Subject: Issuance of Amendment No. 42 to Facility Operating License  
NPF-9 and Amendment No. 23 to Facility Operating License  
NPF-17 - McGuire Nuclear Station, Units 1 and 2

The amendments change the Technical Specifications to reflect the transition to the use of optimized fuel assemblies. The amendments are effective as of their dates of issuance.

Amendment No. 42  
License No. NPF-9

Amendment No. 23  
License No. NPF-17

FIGURE 2.1-1b

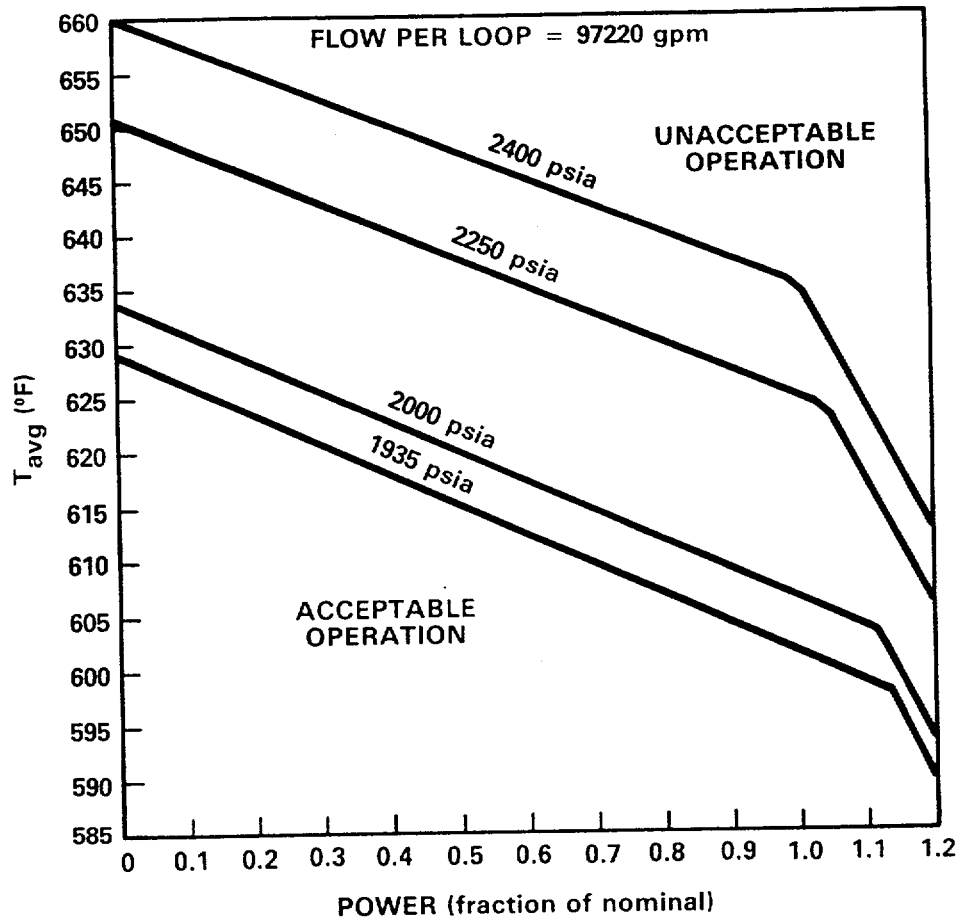
Section 2.1; Figure 2.1-1b: The safety limits for DNB for Unit 2 have not further changed beyond the changes resulting from the use of OFA fuel and corresponding changes in analyses methodology discussed in the Unit 1 SER, but the boiling limits are more restrictive because of the change in core flow. The bases for Section 2.1 have changed to reflect the OFA related thermal-hydraulic methodology changes. These changes are acceptable.

FIGURE 3.1-0  
MODERATOR TEMPERATURE COEFFICIENT VS POWER LEVEL

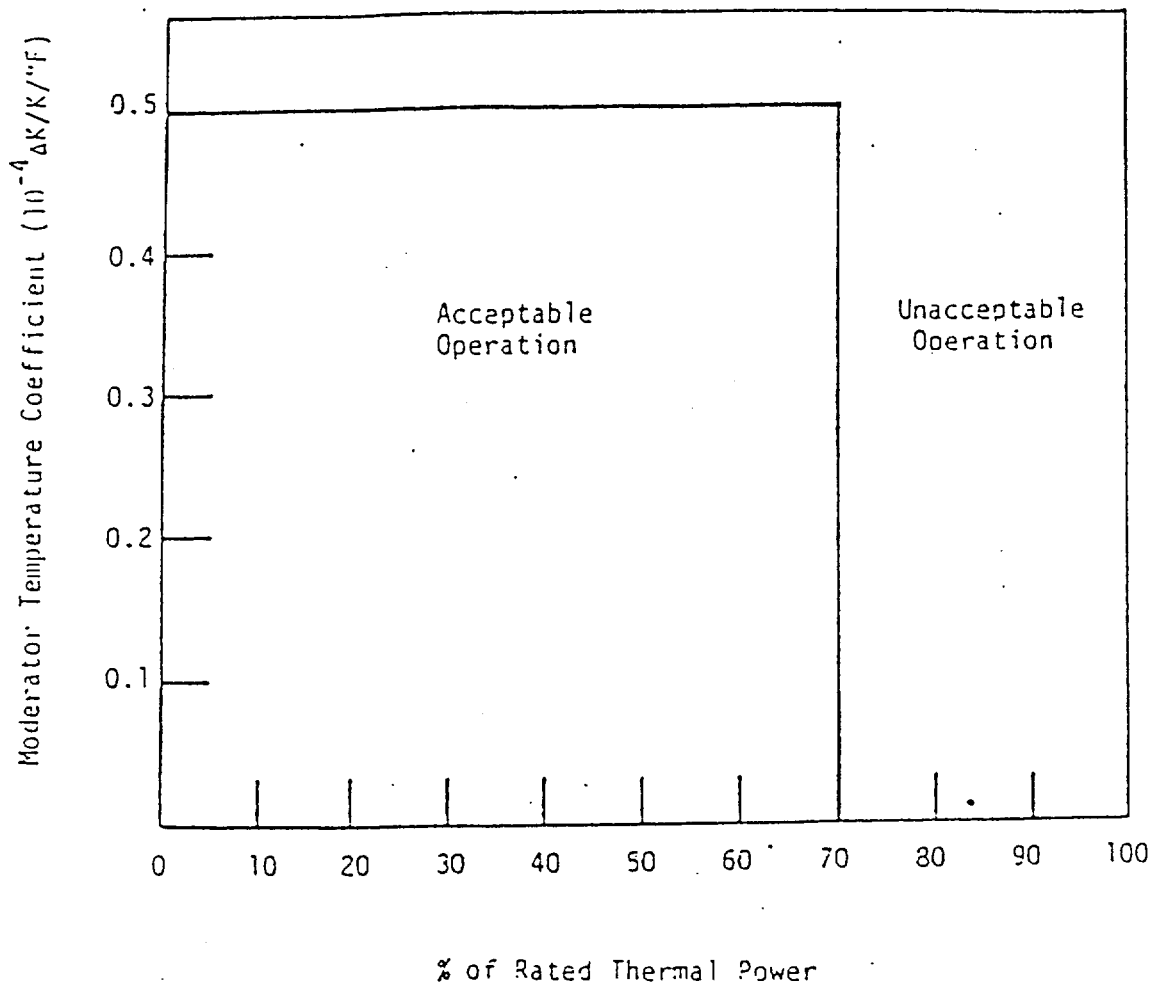
Section 3/4.1.1.3: This change is to allow a positive moderator temperature coefficient as in Unit 1.

- a. Less positive than the limits shown in Figure 3.1-0, and
- b. Less negative than  $-4.1 \times 10^{-4}$  delta k/k/°F for the all rods withdrawn, end of cycle life (EOL), RATED THERMAL POWER condition.

FIGURE 3.2-1  
AXIAL FLUX DIFFERENCE LIMITS AS A FUNCTION OF RATED THERMAL POWER

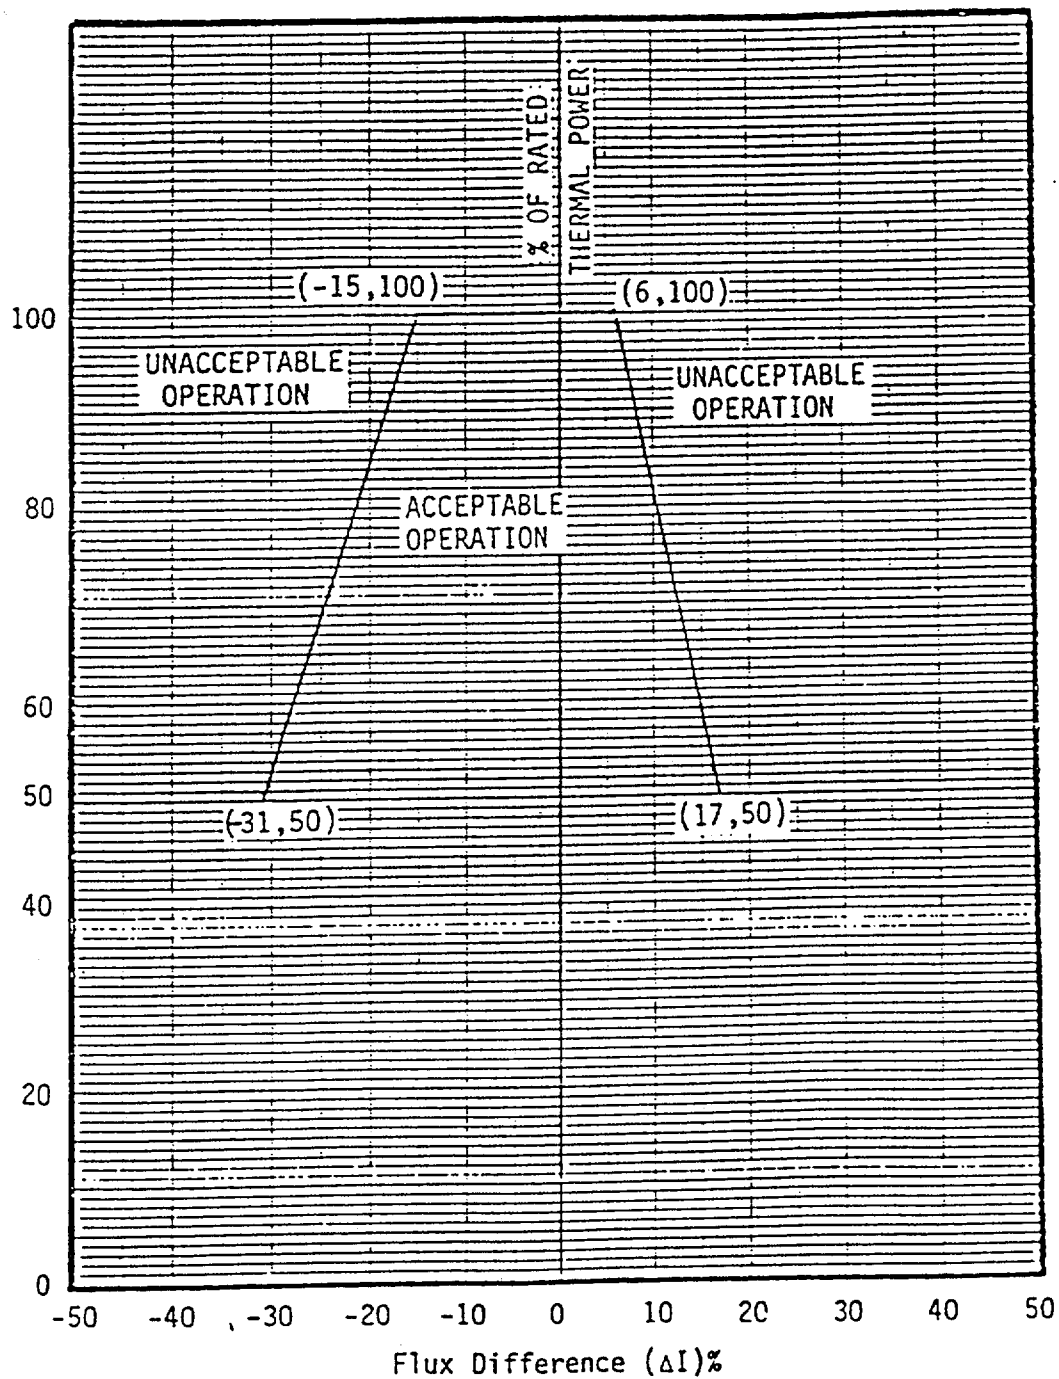
Section 3/4.2.1 and Bases: The change is from CAOC to RAOC and Base Load Operation as in Unit 1 (including the supplemental review for Unit 1 Base Load).

- a. the allowed operational space defined by Figure 3.2-1 for RAOC operation, or
- b. within a  $\pm 3$  (Unit 1), 5 (Unit 2) percent target band about the target flux difference during base load operation.

FIGURE 3.2-2b

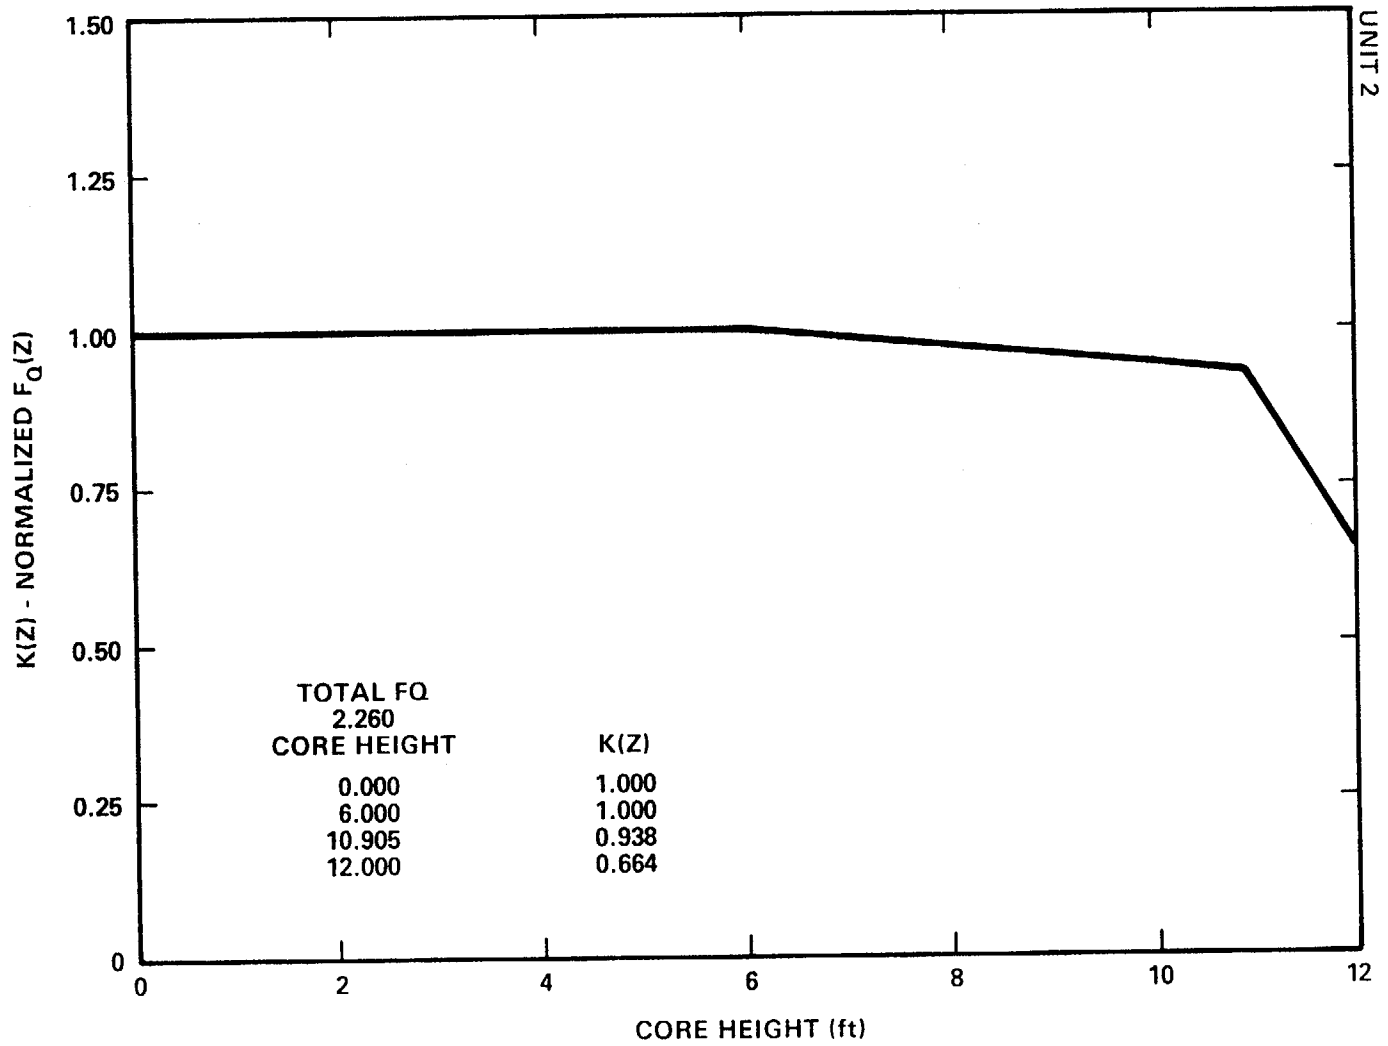
Section 3/4.2.2: The change in Unit 2 to an  $F_Q$  of 2.26 is approved as a result of the approval of the LOCA analysis using this value. The change to  $F_Q$  surveillance (from  $F_{xy}$  surveillance) is as in Unit 1.

where  $F_Q^M(z)$  is the measured  $F_Q(z)$  increased by the allowances for manufacturing tolerances and measurement uncertainty, 2.15 (Unit 1) and 2.26 (Unit 2) is the  $F_Q$  limit,  $K(z)$  is given in Figure 3.2-2,  $P$  is the relative THERMAL POWER, and  $W(z)$  is the cycle dependent function that accounts for power distribution transients encountered during normal operation. This function is given in the Peaking Factor Limit Report as per Specification 6.9.1.9.

Figure 3.2-3b RCS FLOW RATE VERSUS R - FOUR LOOPS IN OPERATION (Unit 2)

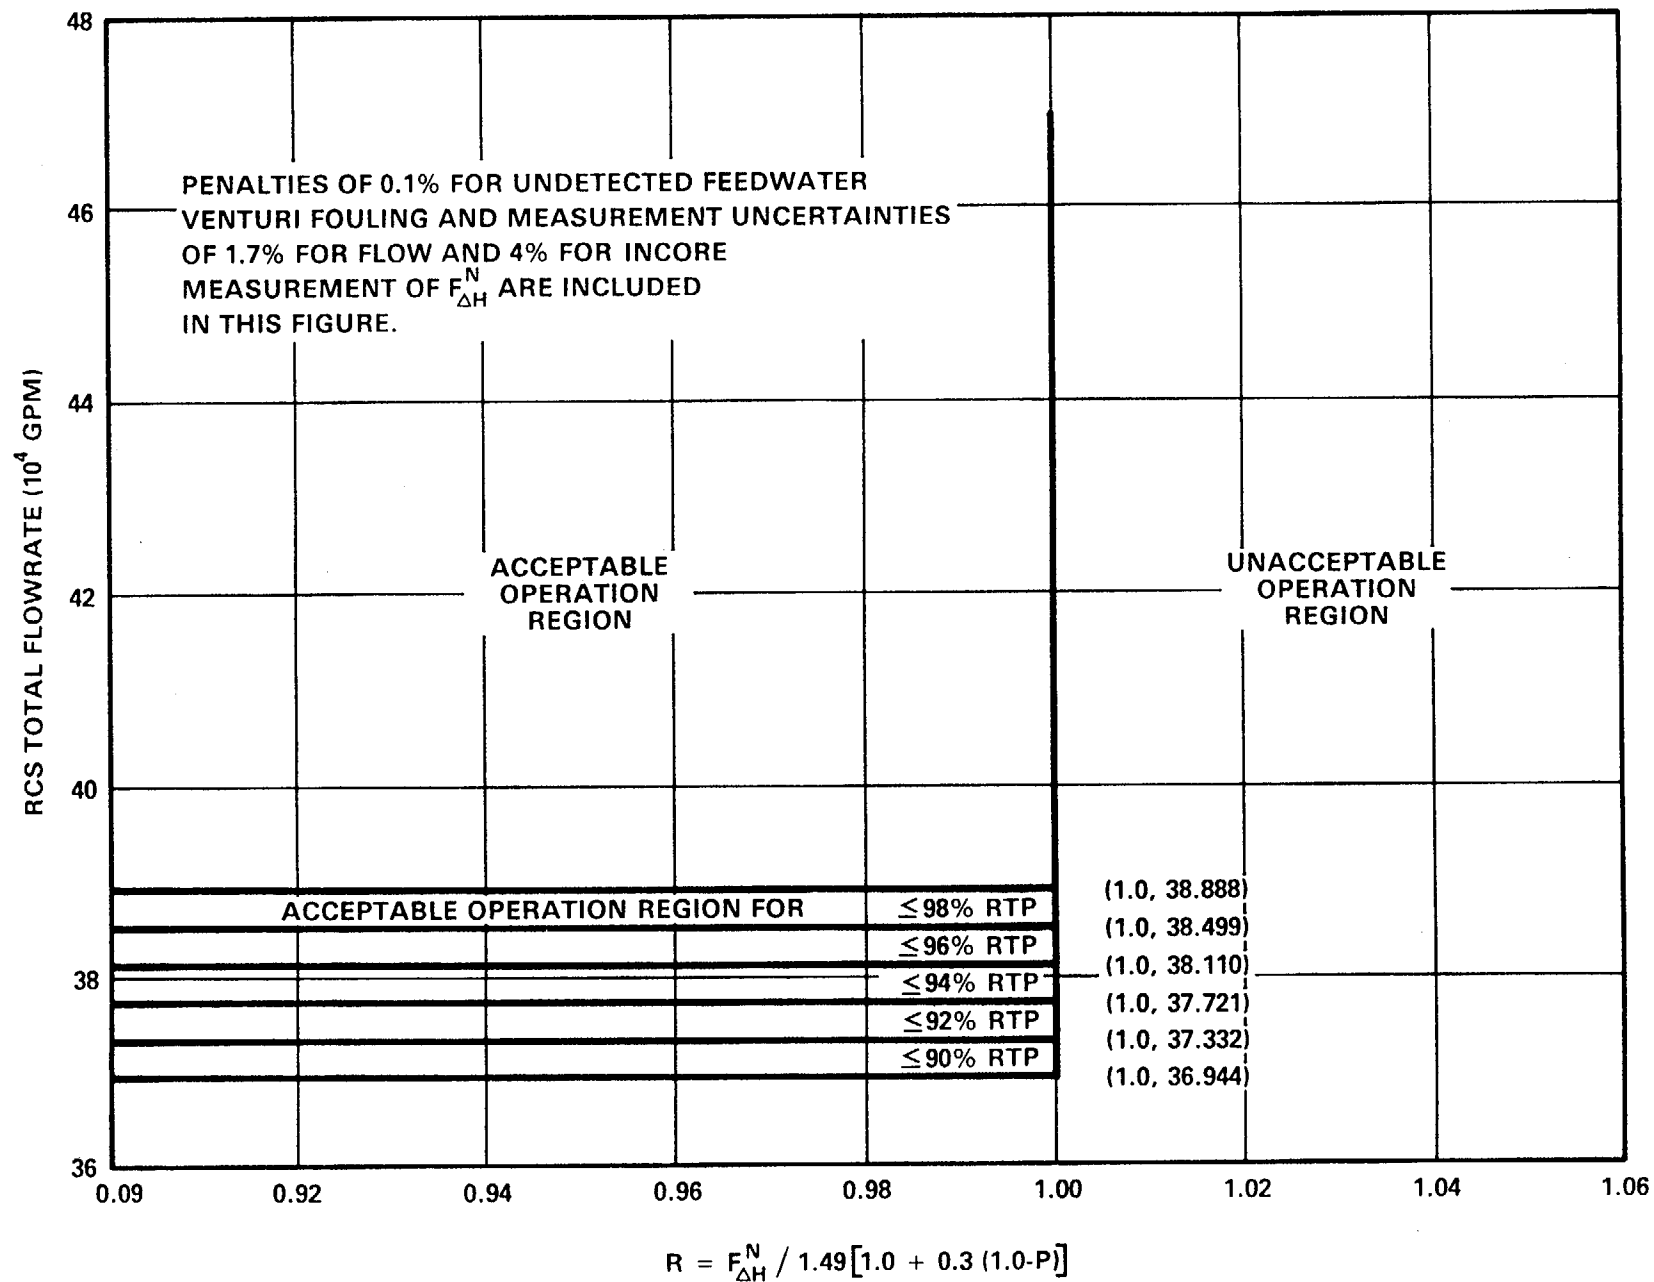
Section 3/4.2.3: The change in the  $F_{\Delta H}$  power factor from 0.2 to 0.3 and the elimination of the rod bow factor are as in Unit 1.

3.2.3 The combination of indicated Reactor Coolant System (RCS) total flow rate and R shall be maintained within the region of allowable operation shown on Figure 3.2-3 for four loop operation:
